PLANNING AND ZONING CASE CHECKLIST

P&Z CASE # SP2018-042 P&Z DATE 1/15/19 CC DATE 1/22/19 APPROVED/DENIED _____
ARCHITECTURAL REVIEW BOARD DATE _____ HPAB DATE _____ PARK BOARD DATE _____

Project Number: SP2018-042
Project Name: 2500 Discovery Blvd.
Project Type: SITE PLAN
Applicant Name: [APPLICANT]
Owner Name: Z06, PROPERTIES INC
Project Description:

AGENDA ITEM: **SP2018-042**; *Site Plan for Office/Warehouse Building Expansion*

date: 12/13/18 scale: 1"=40' sheet: C101

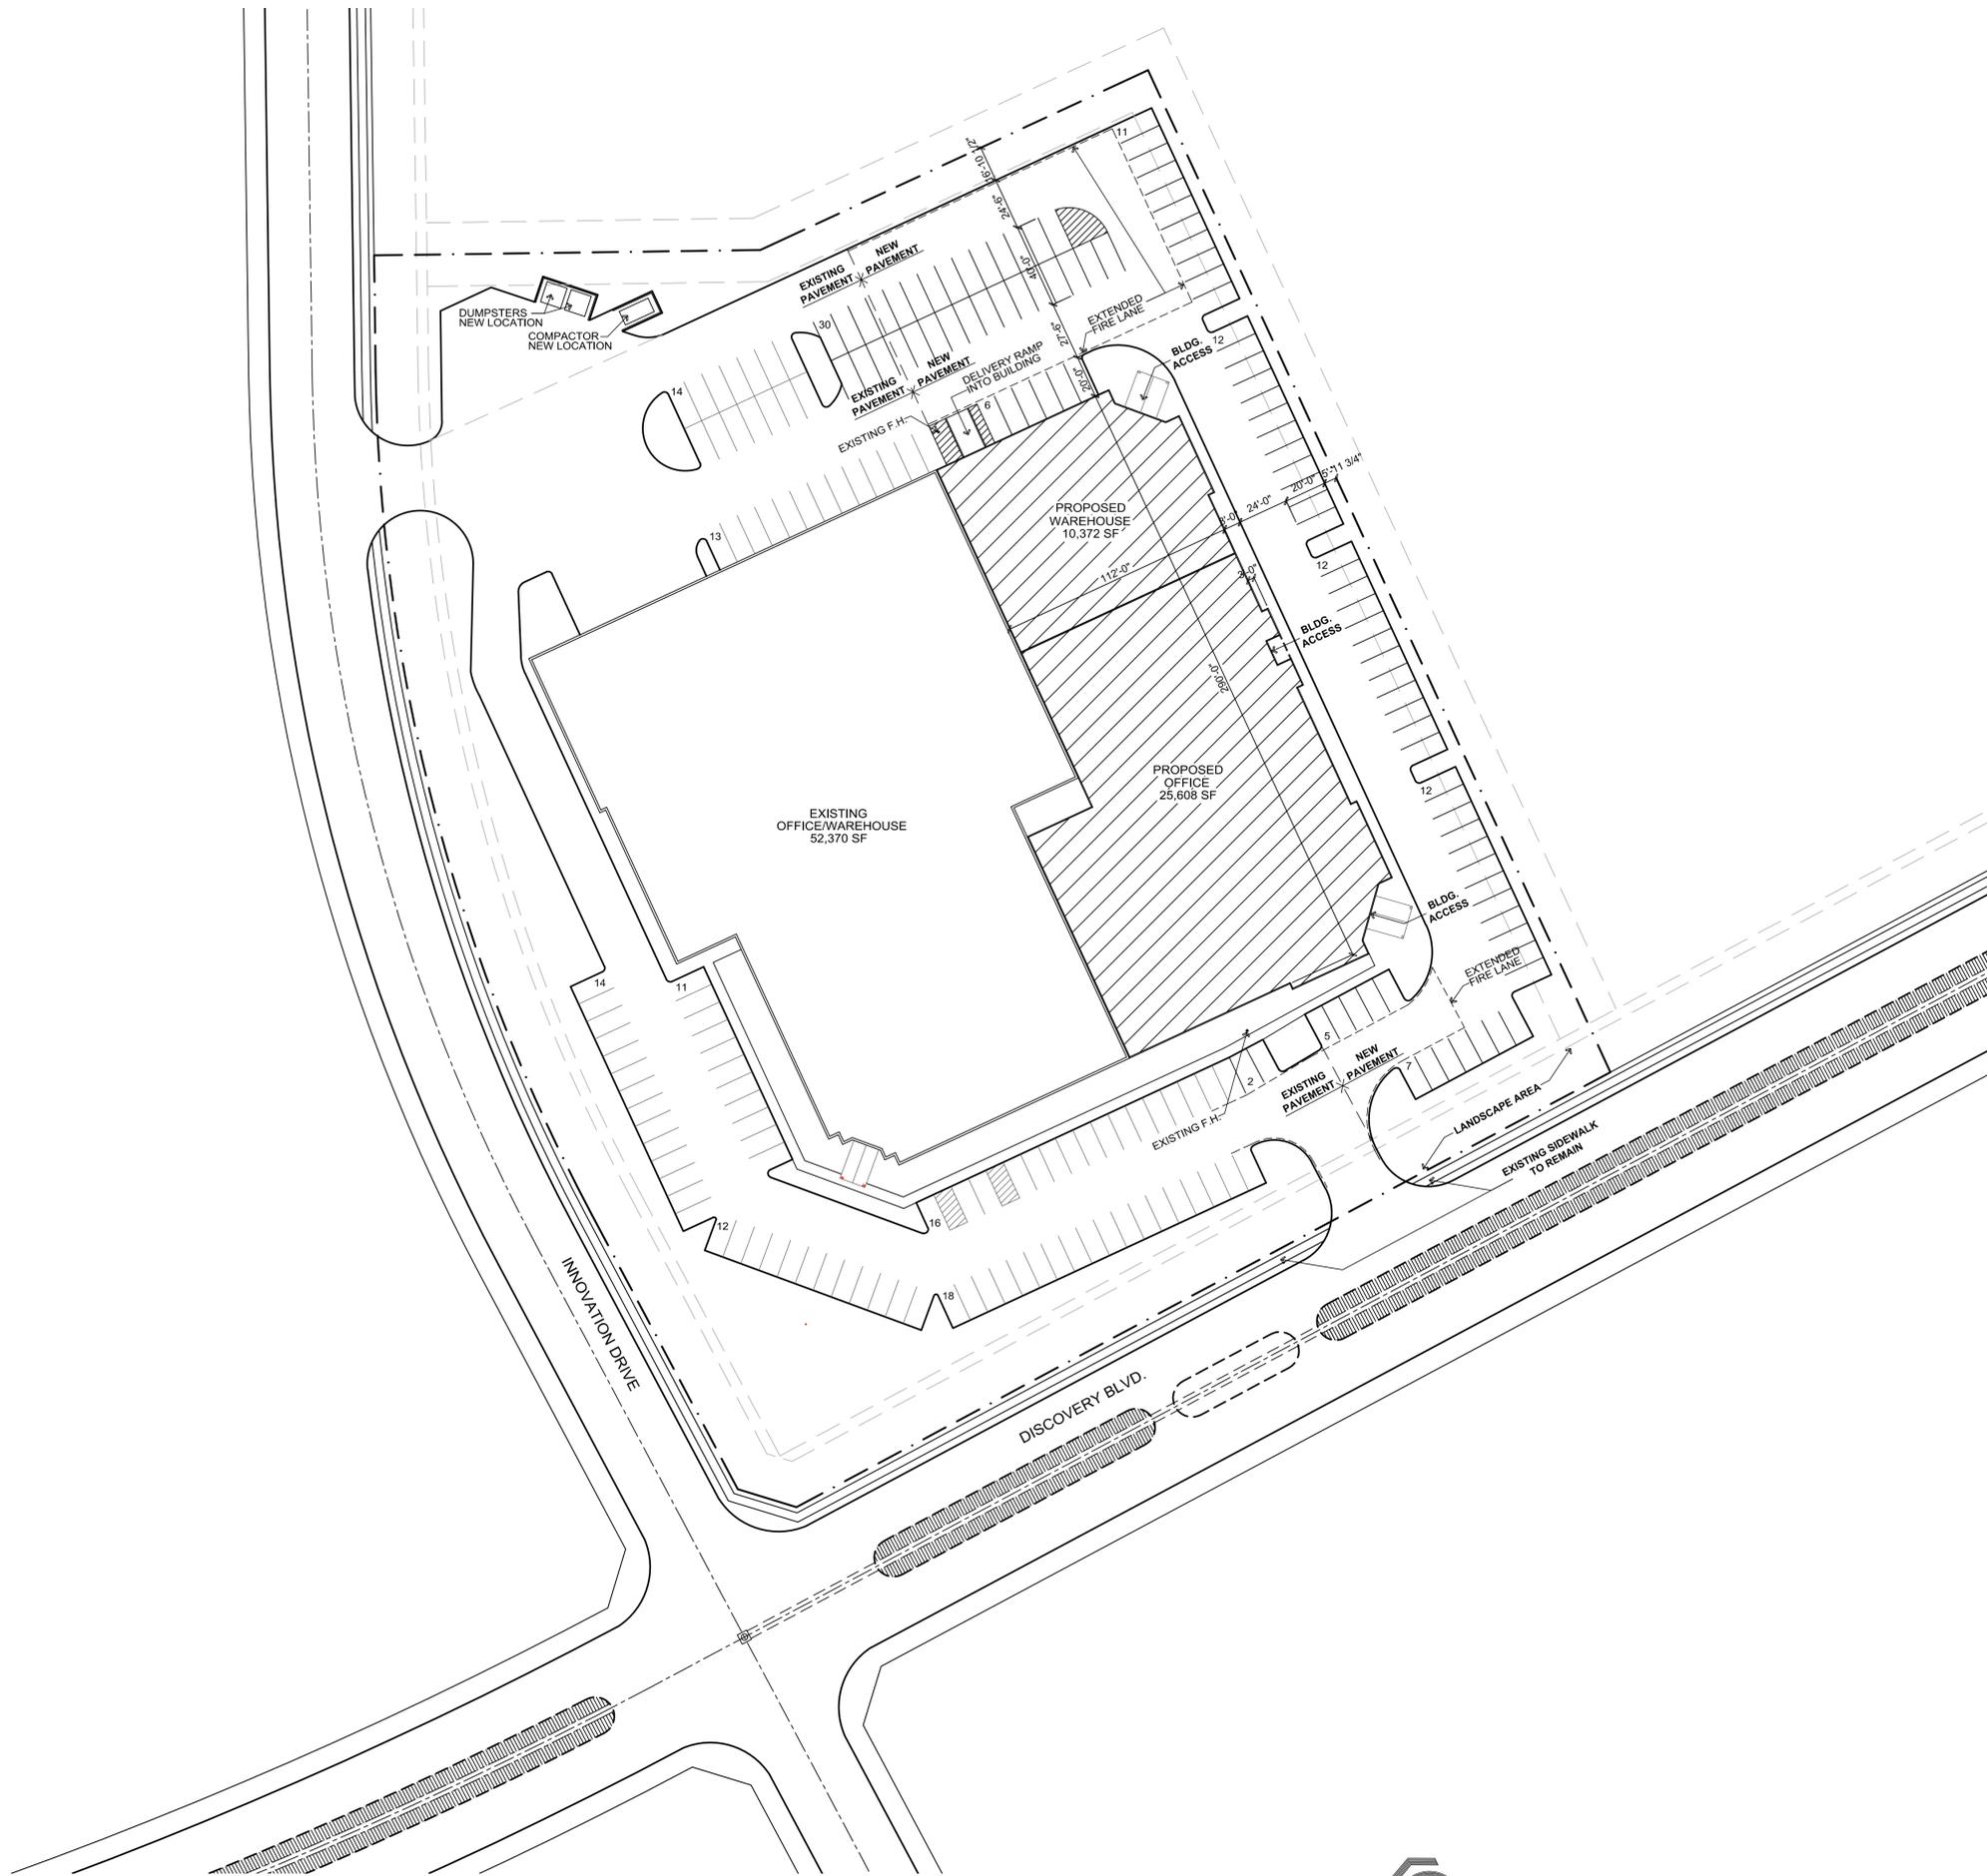
Site Plan:

1. Provide adjacent property owner information
2. Label the access easement as "24-ft Firelane, Public Access, and Utility Easement.
3. Delineate and label all easements for site.
4. Provide a hatch for the proposed building area(s).
5. Relabel the northern portion of the expanded building - says "Prop Delivery Ramp"
6. Use a heavier font weight for the fonts in light gray under Site Data
7. Correct Title Block to read "Lot 3", Block D.

ARCHITECTURAL SITE PLAN

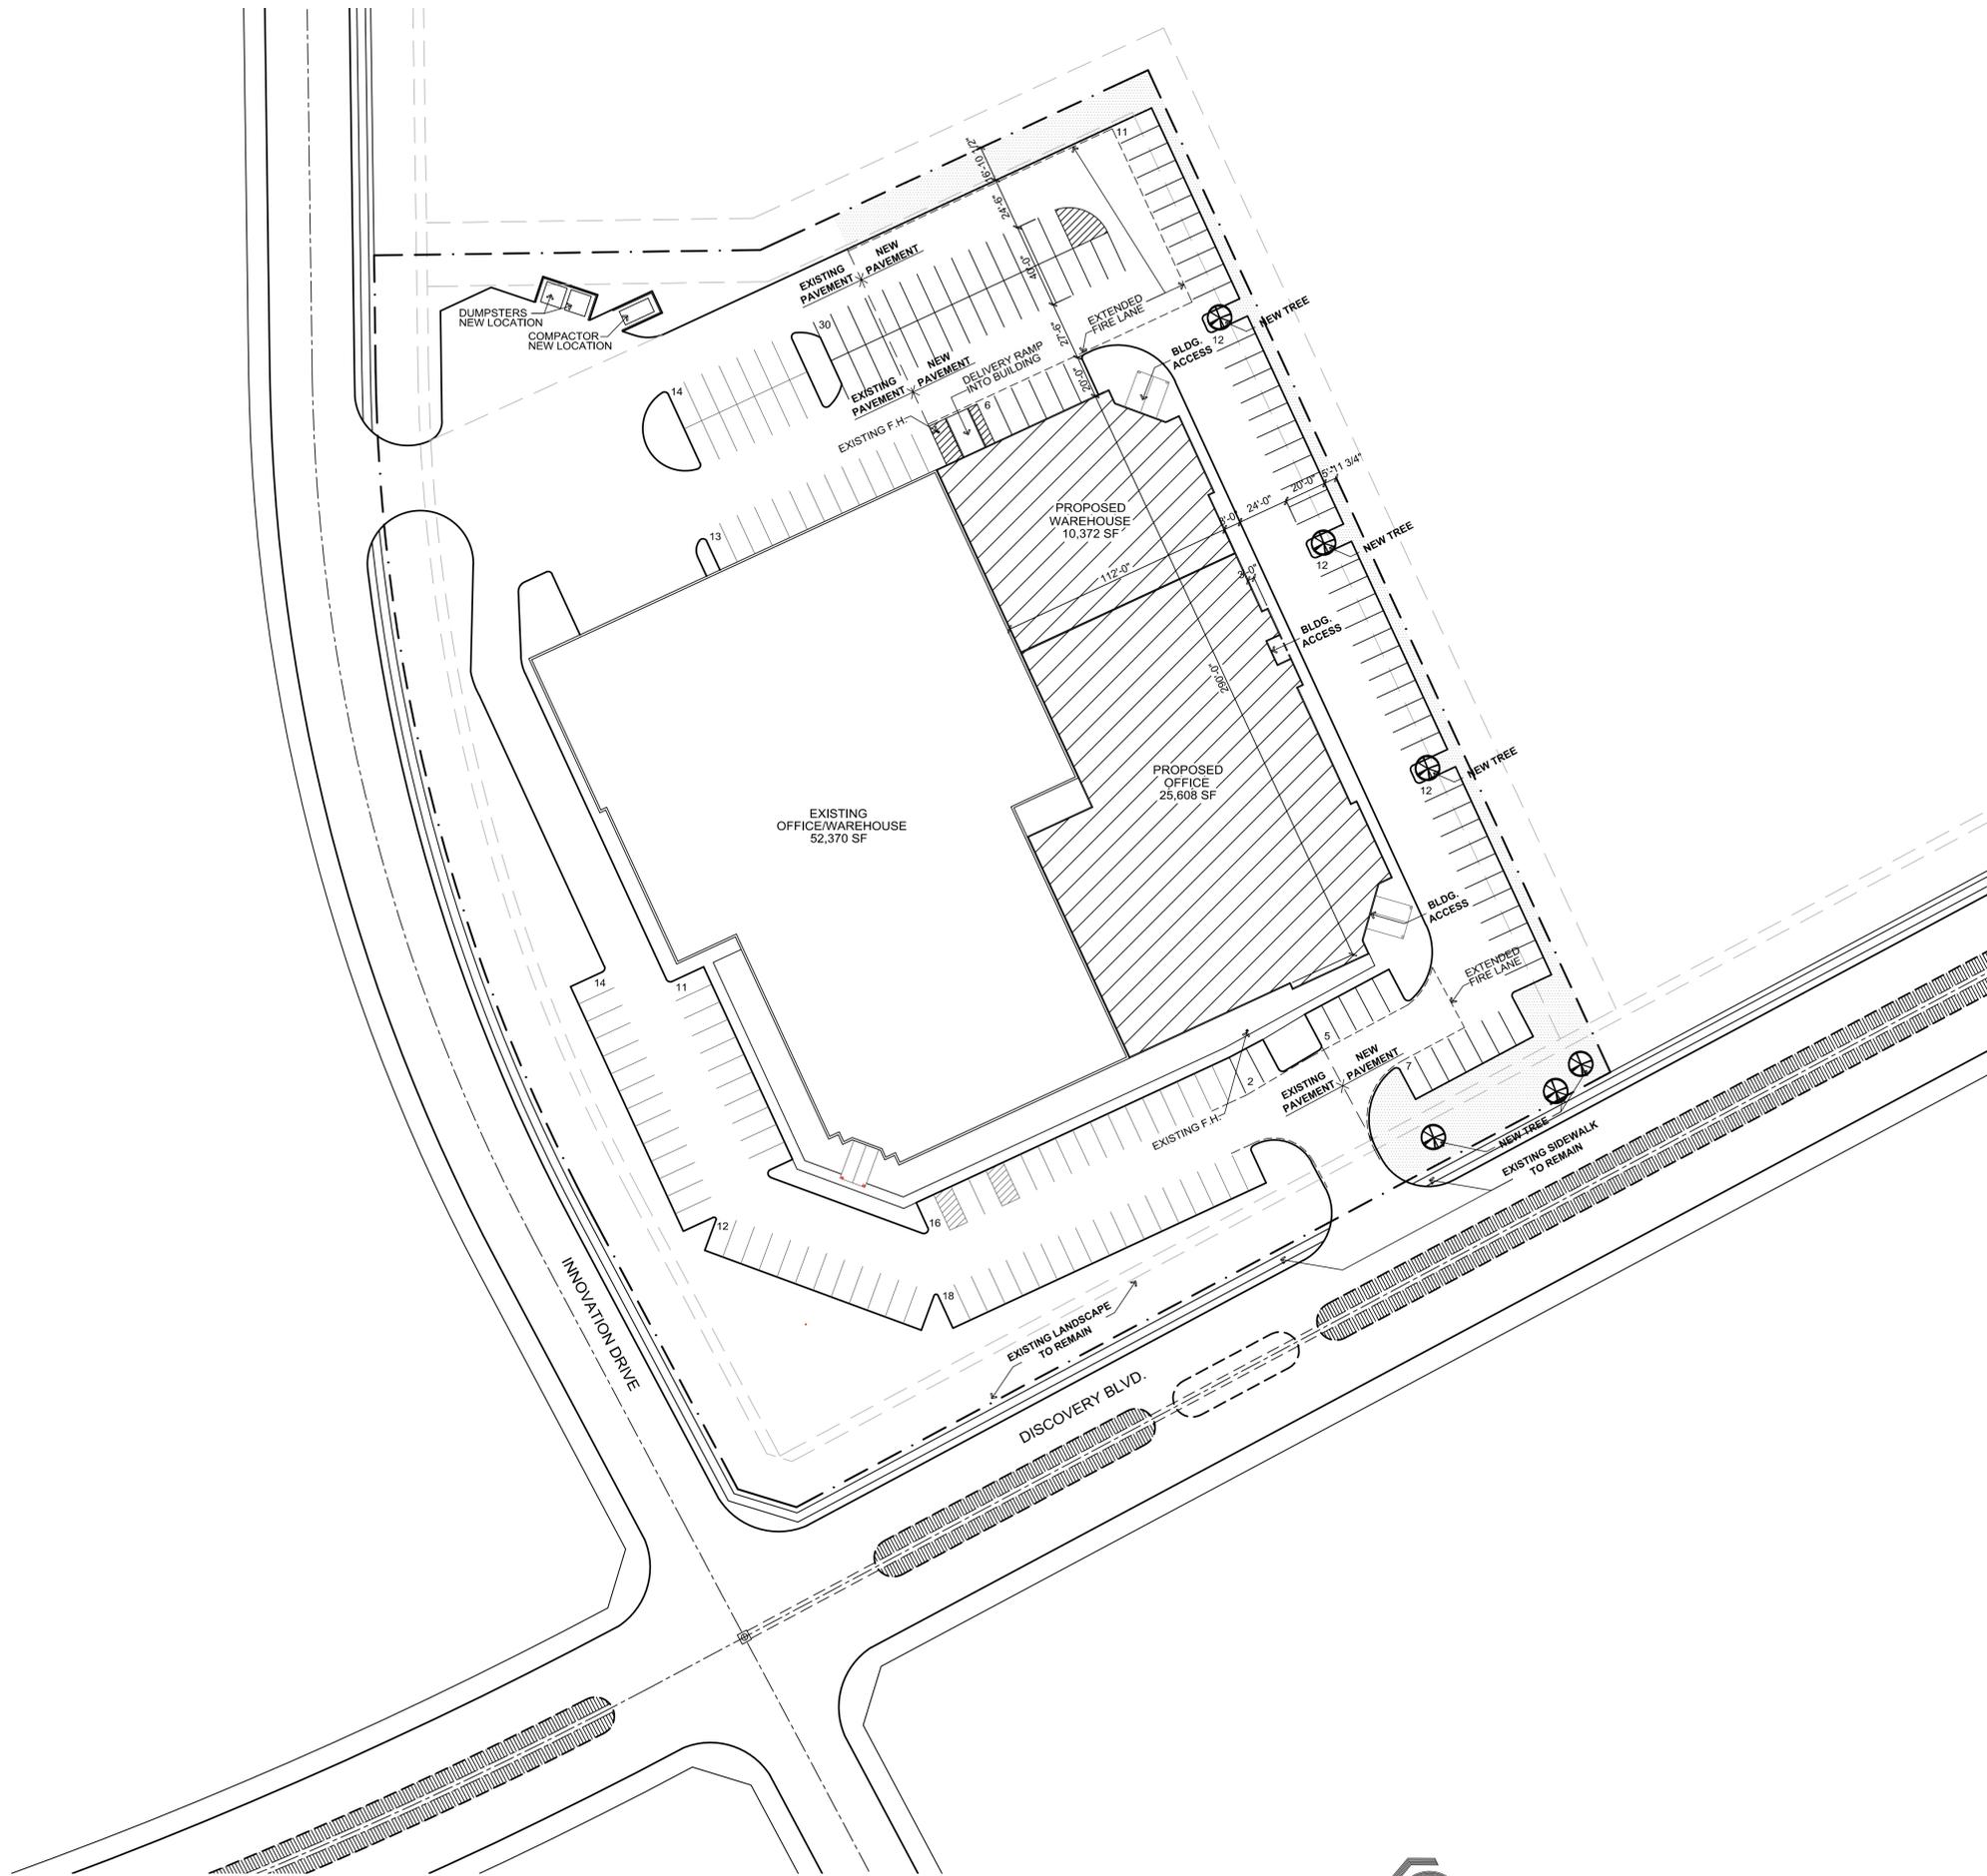
Architectural Site Plan:

1. Correct Site Data Table to indicate "Light Industrial" for the zoning of the property.

LANDSCAPING PLAN

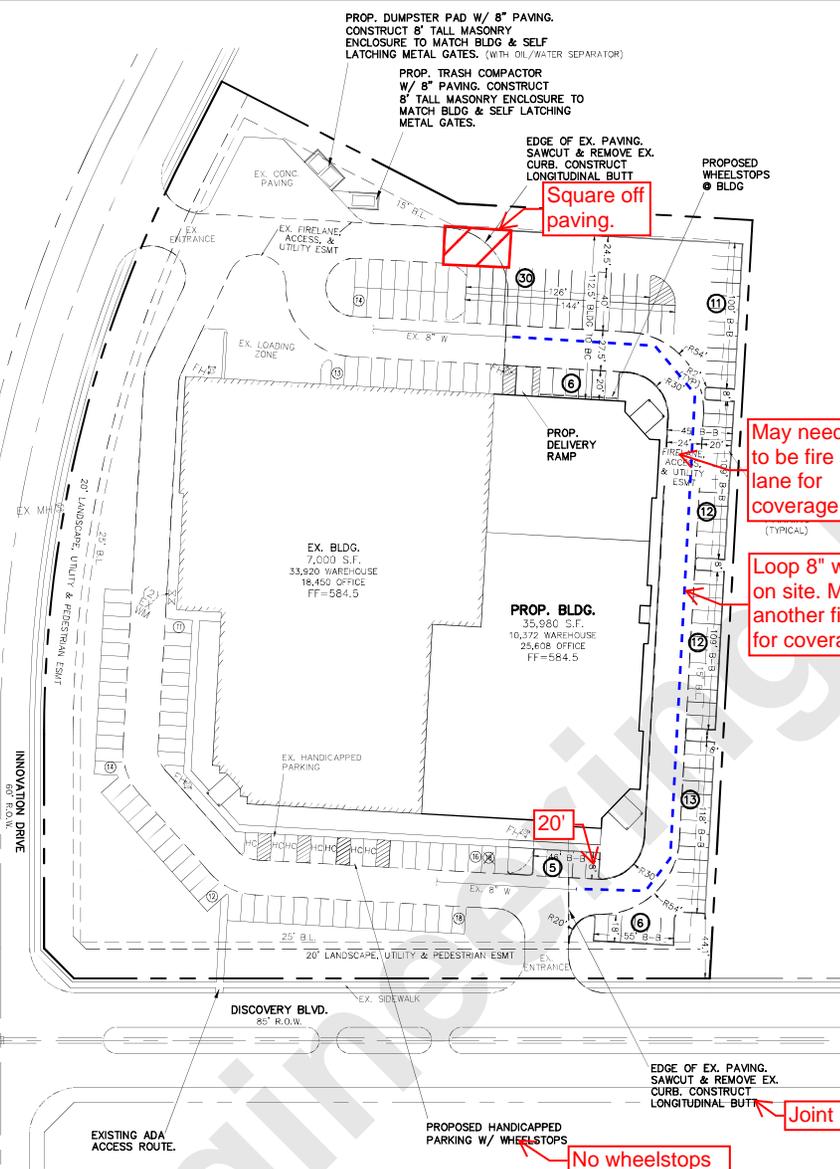
Landscape Plan:

1. A treescape plan is required for the removal of trees located on this site. See mitigation requirements for those trees requiring mitigation under Article IX, Tree Preservation, of the UDC.
2. Update landscape to indicate compliance with landscape standards of the UDC by providing a minimum of one (1), three (3)-caliper inch canopy tree per each 50 linear feet and within the 20-ft landscape buffer along each street
3. Provide a minimum of one (1), three (3)-caliper inch tree for each ten (10) parking spaces within the interior of the parking lot.

Type of Review / Notes	Contact	Sent	Due	Received	Elapsed Status	Remarks
4. No required parking space may be located more than 80 feet from the trunk of a large canopy tree

5. Delineate and label the 20-ft Landscape buffer strip along each adjacent street						
Photometric Plan:						
1. Are there any additional exterior lighting fixtures, poles to be used on this expansion? If so, provide a photometric plan complying with the standards as established in Section 3, of Article VII, Environmental Performance, of the UDC.						
Building Elevations:

date: 12/13/18 scale: 1"=40' sheet: C101

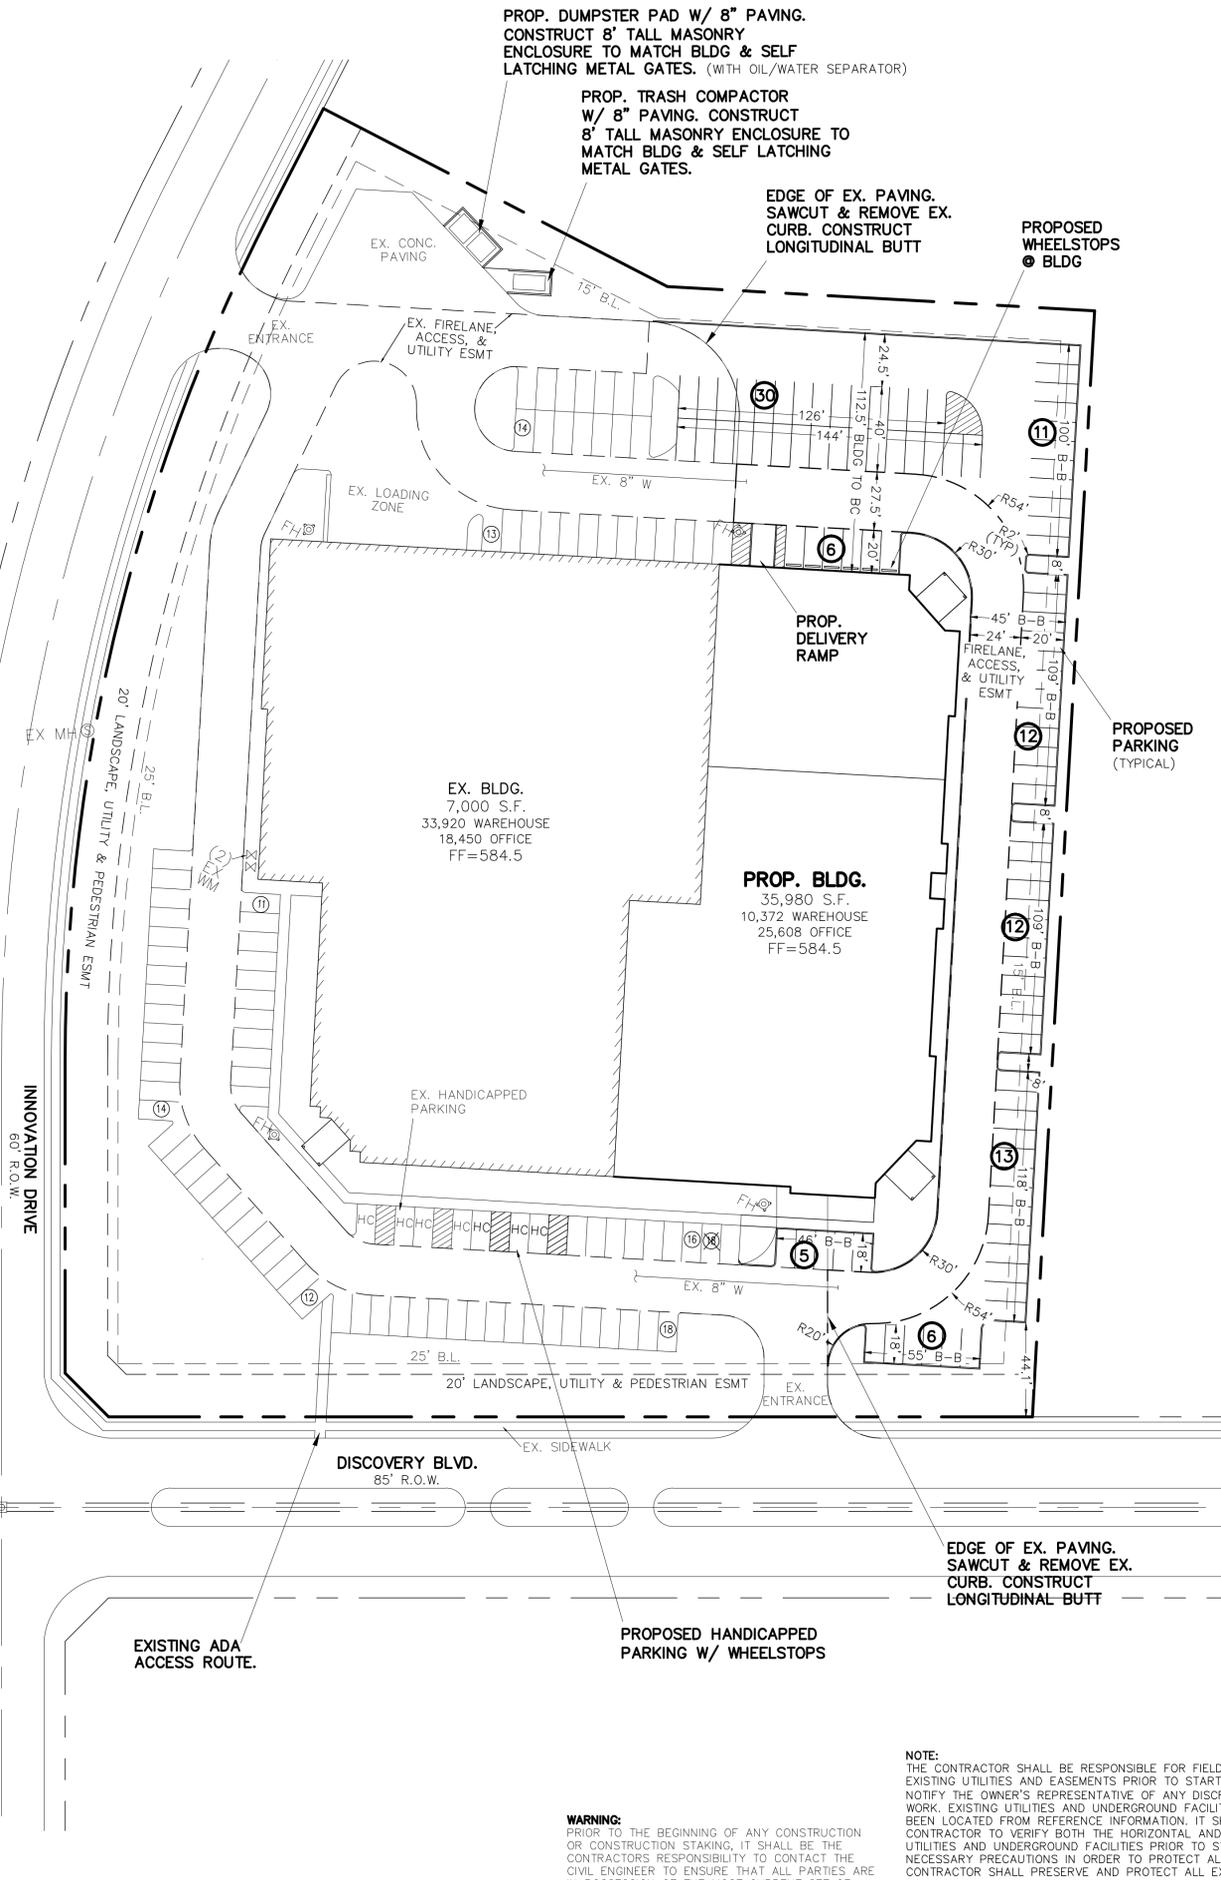
- 4% Engineering Inspection Fees.
- Impact fees for taps and upsizing the building.
- Fire Lane to be 24' min, 20' curve radii.
- Parking is 20'x9' min.
- Min 20' utility easements.
- No structures or walls in easements.
- No trees within 5' of public utilities.
- Retaining walls 3' and over must be designed by a licensed engineer. All walls to be rock or stone. No smooth concrete walls.
- Lot must be replatted.
- Must meet all City Engineering Standards.
